CONTRACT NO. 1797

OHIO RIVER TUNNEL

**ADDENDUM No. 4**

All bidders bidding **Contract No. 1797** shall read and take note of this **Addendum No. 4**. The Contract Documents for **Contract No. 1797 – Ohio River Tunnel** are hereby revised and/or clarified as stated below.

| ORT-ST-200<br>041 DROP SHAFT<br>SUPPORT OF EXCAVATION - SHEET 1 OF 2     |  |

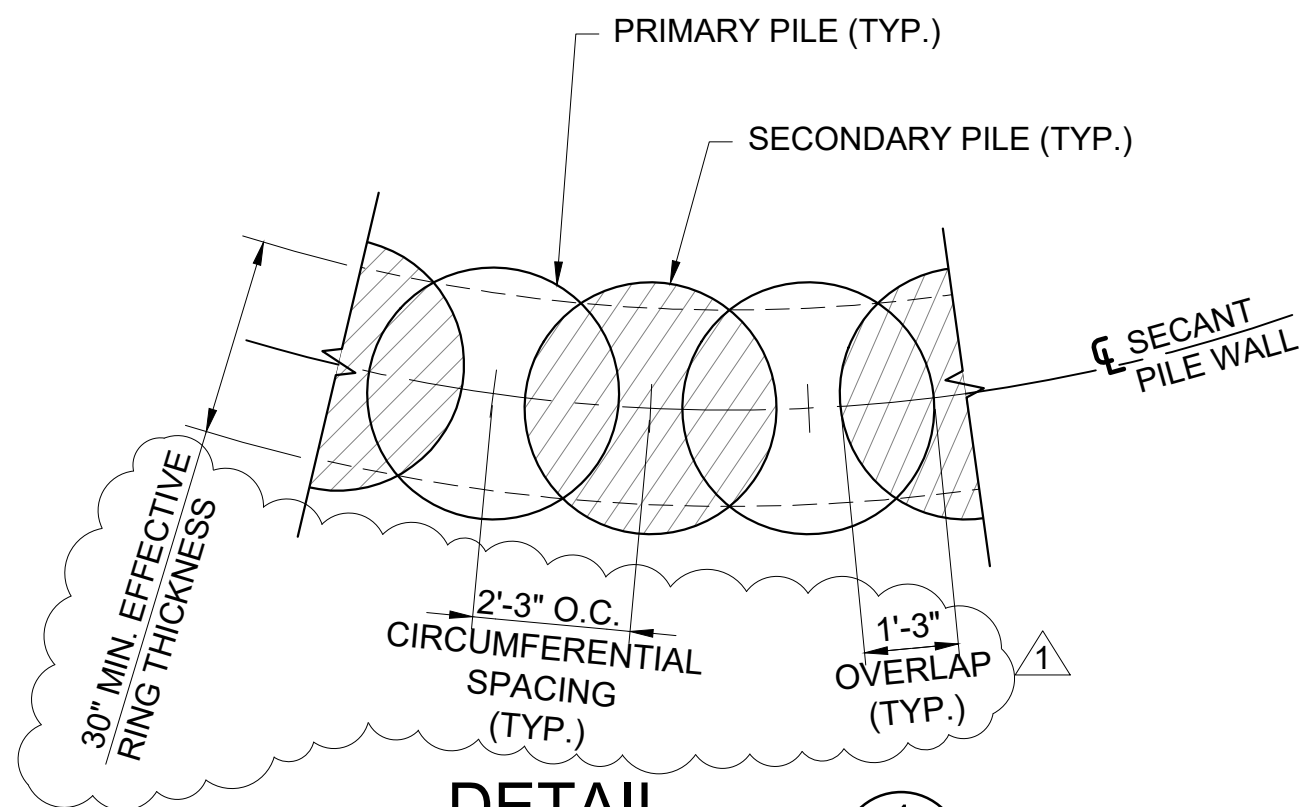
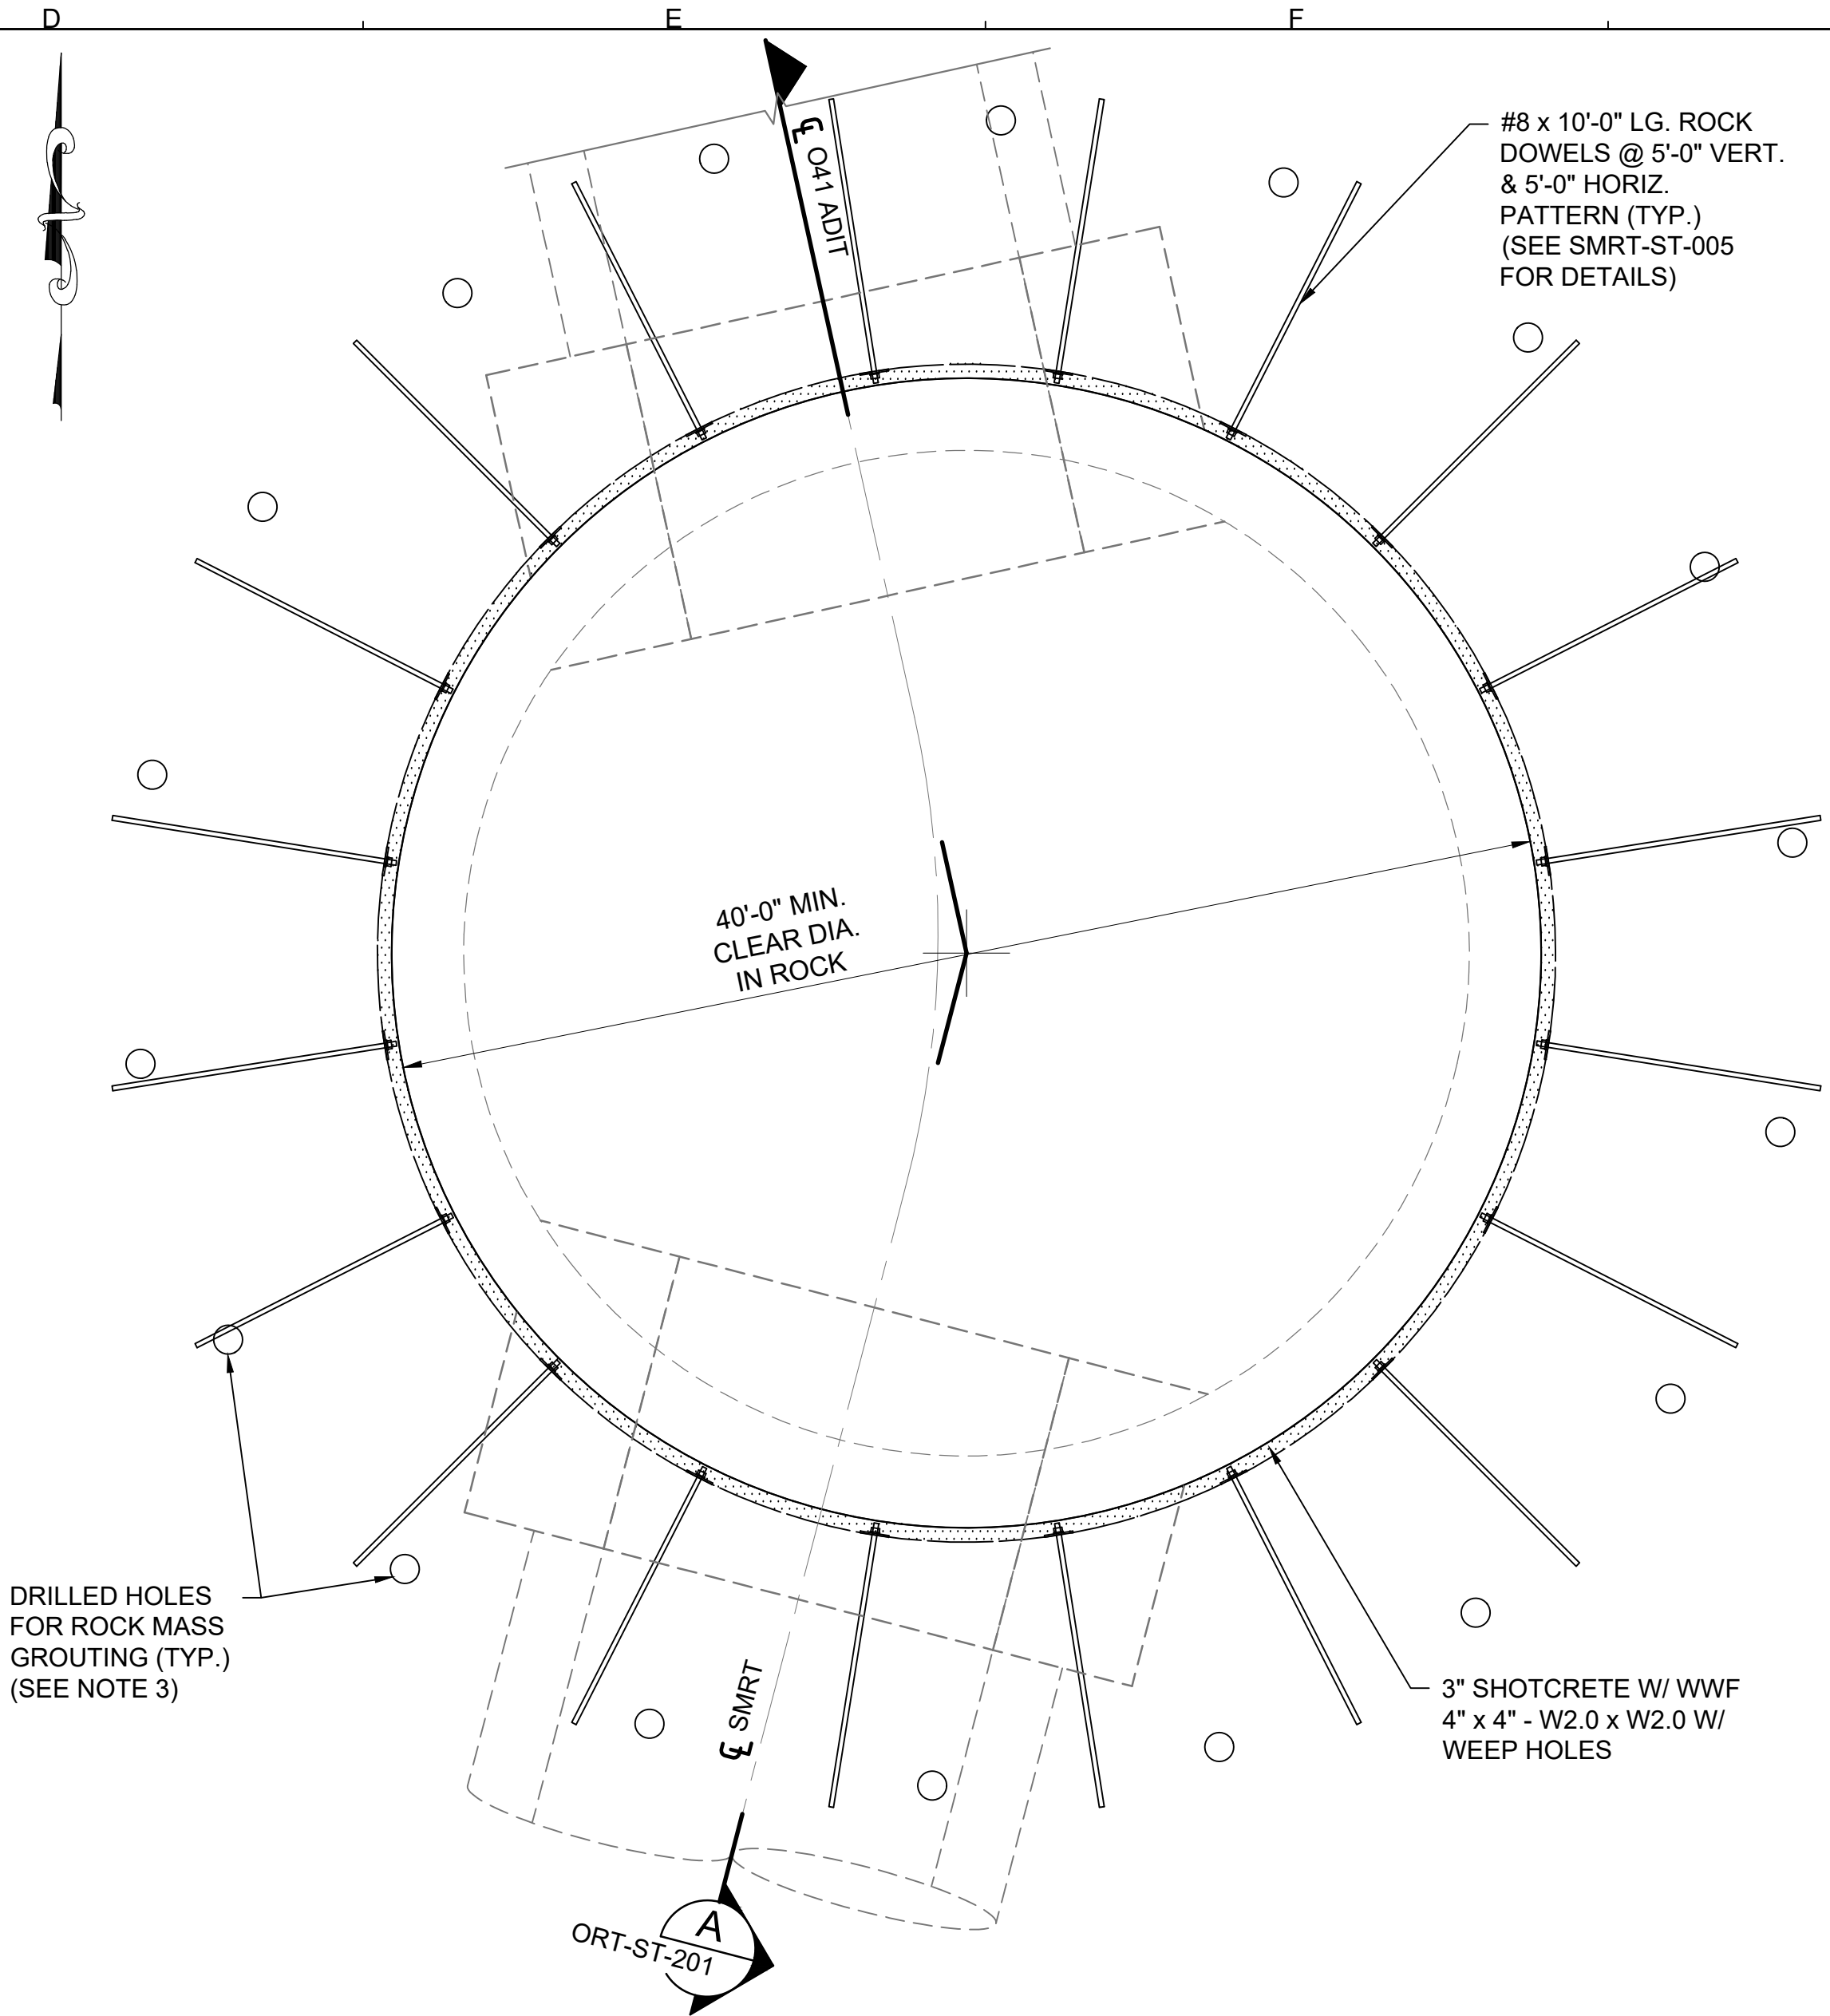
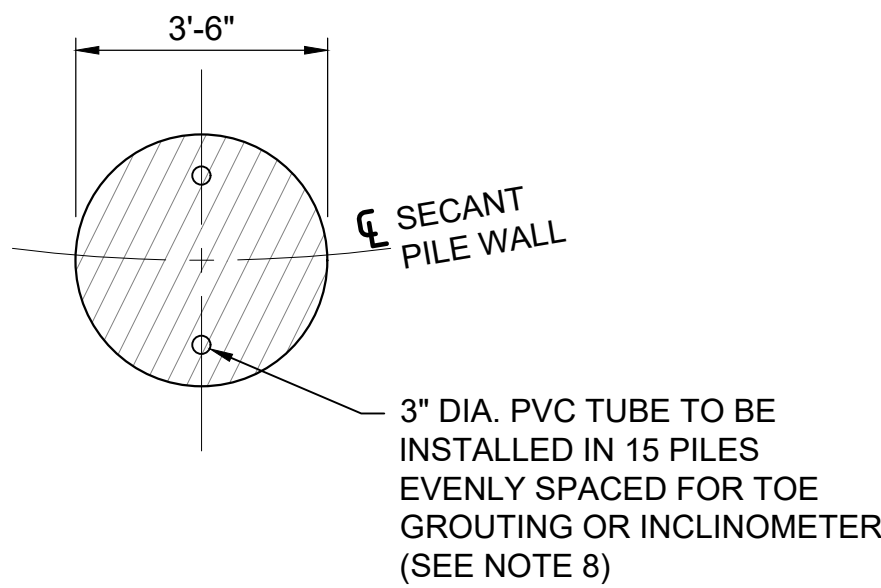
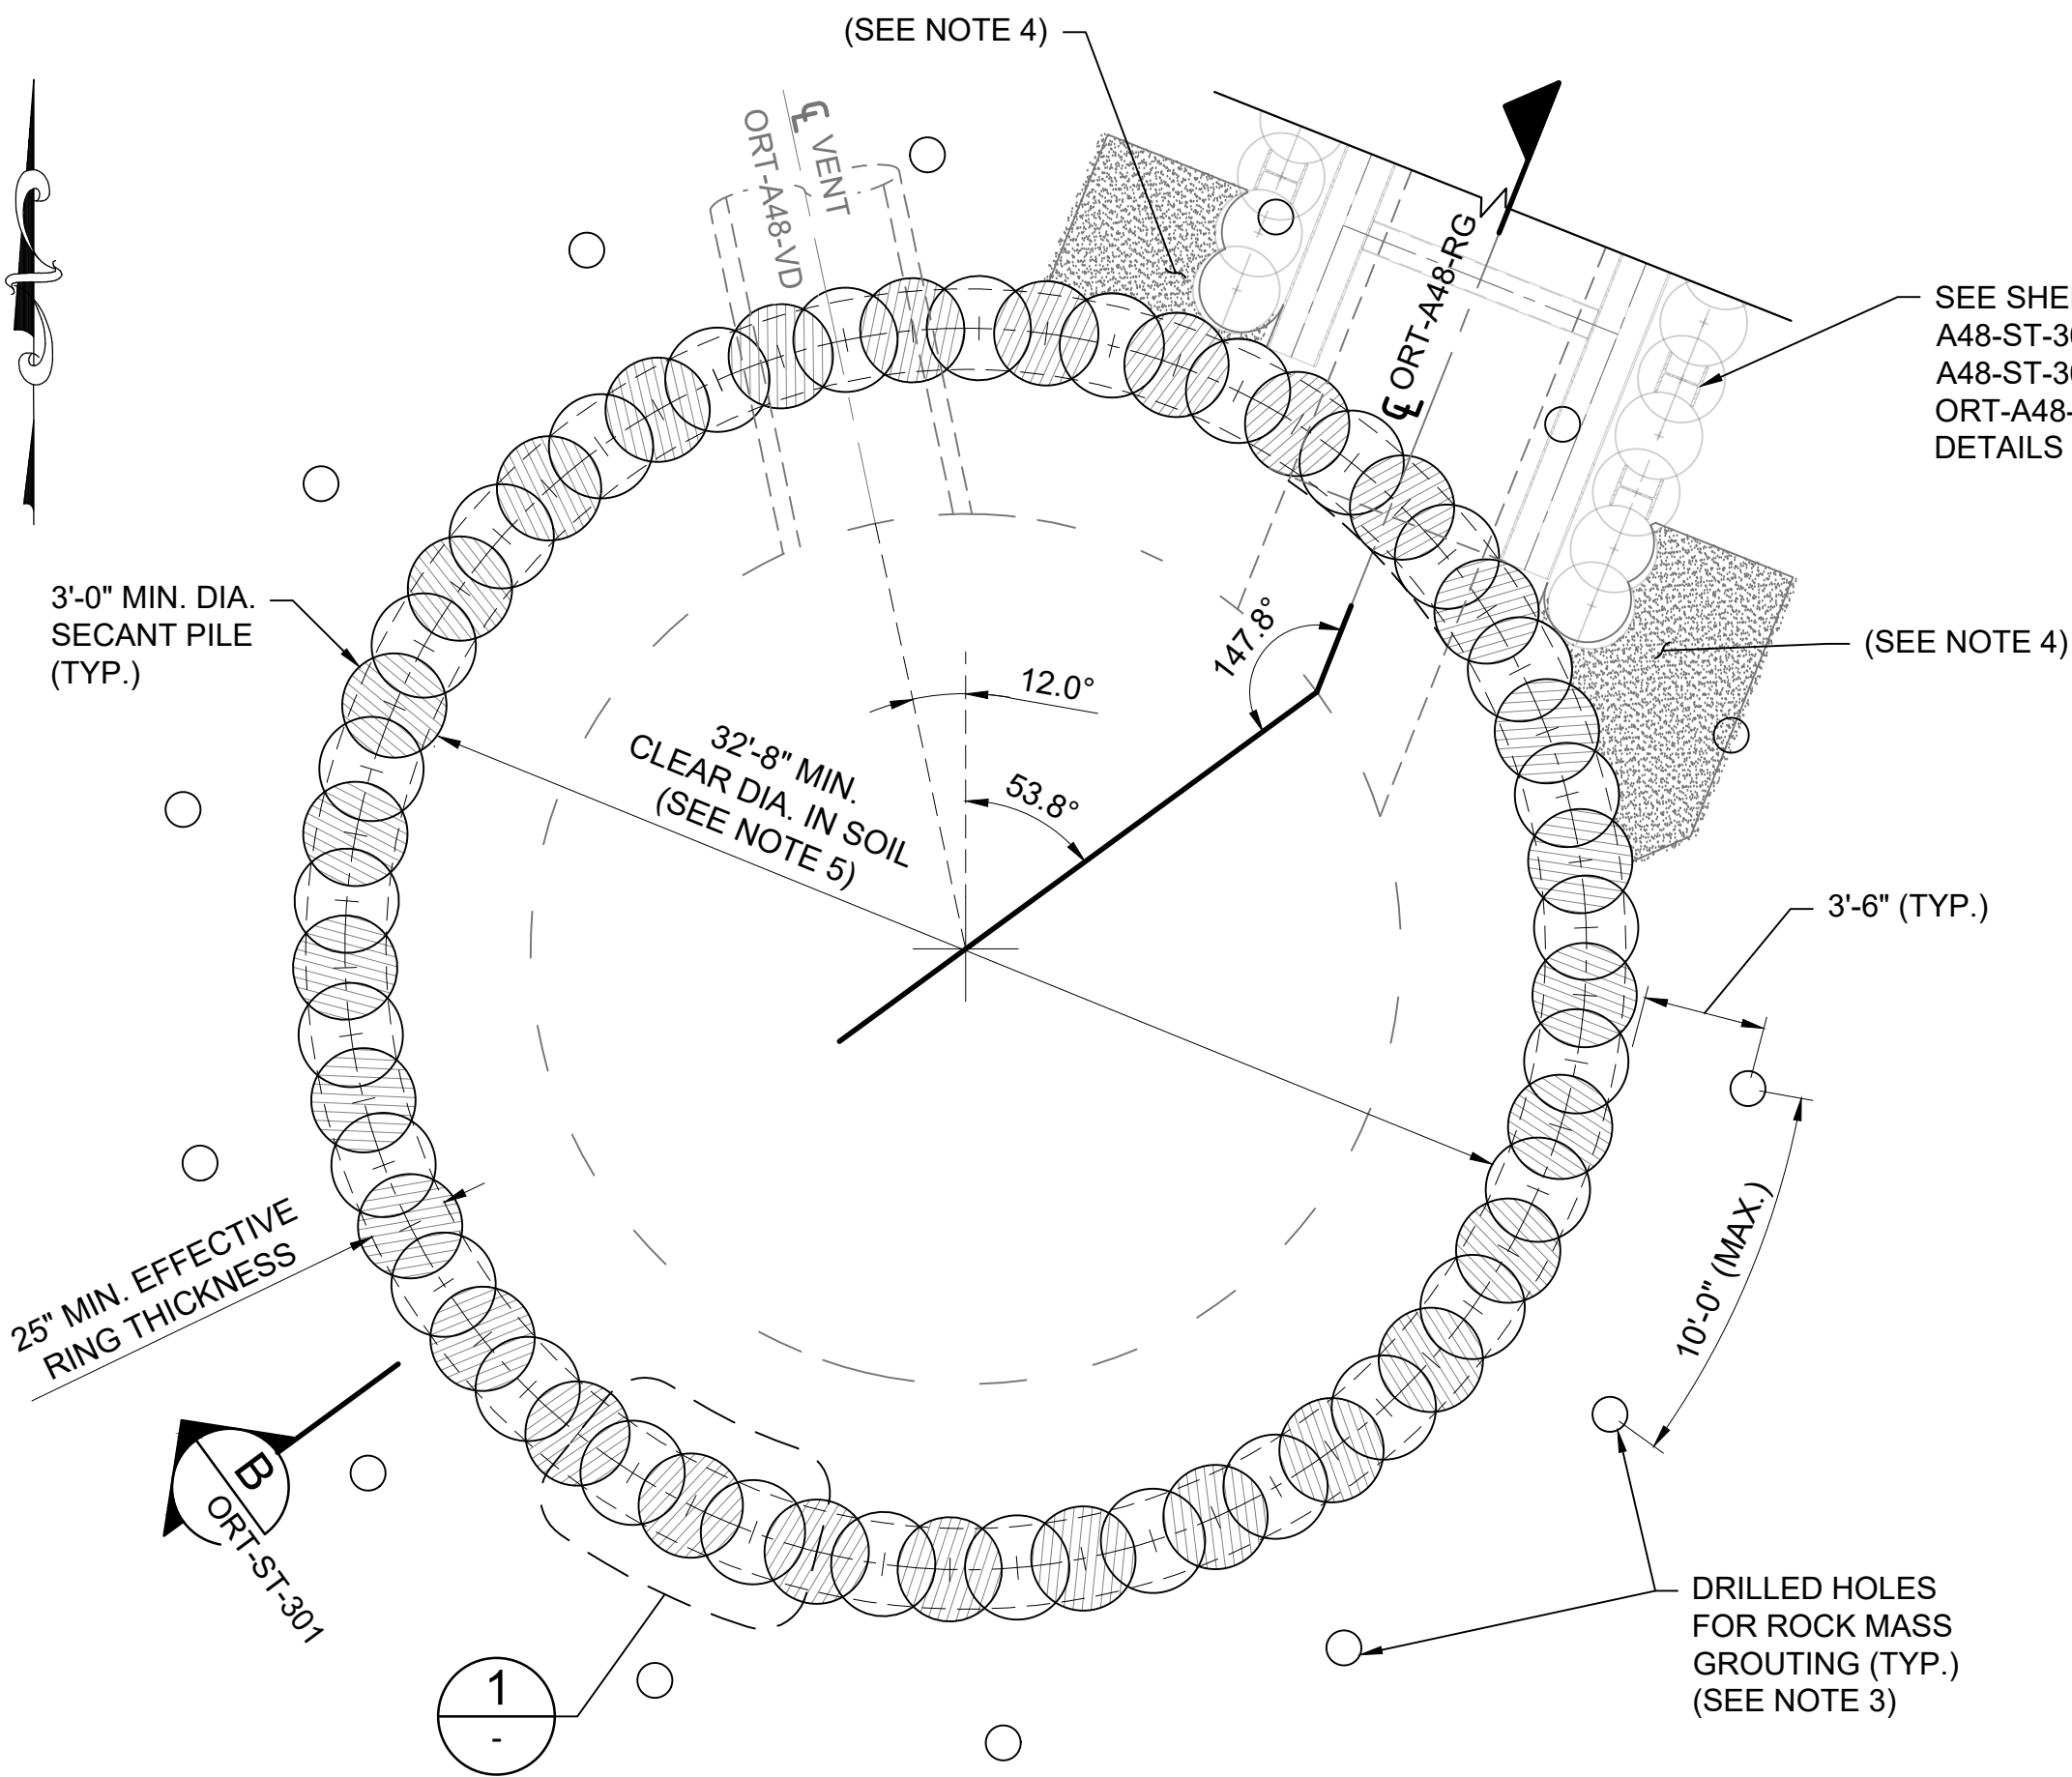
- Q15 *Drawing ORT-ST-200-O41 (sheet 117 of 770) plan view identifies a 3'-0" min diameter secant pile (typ). However, Detail 1 on the same sheet identifies a 3'-6" diameter pile. Further, the detail show a center to center pile distance of 2'-4", but laying out with 3'-6" piles nets an overlap of only 1'-2" and not the required 1'-4" overlap. Please advise.*

- A15 **The following APPENDIX B – CONTRACT DRAWINGS have been revised: ORT-ST-200, ORT-ST-300, ORT-ST-400, ORT-ST-600, ORT-ST-700 AND ORT-ST-800. See Attachment C of this Addendum.**

9. APPENDIX B – CONTRACT DRAWINGS
  - a) DELETE ORT-ST-200 (Sheet 117 of 770) and ADD Revised ORT-ST-200 (Sheet 117 of 770), which is Attachment C to this Addendum.
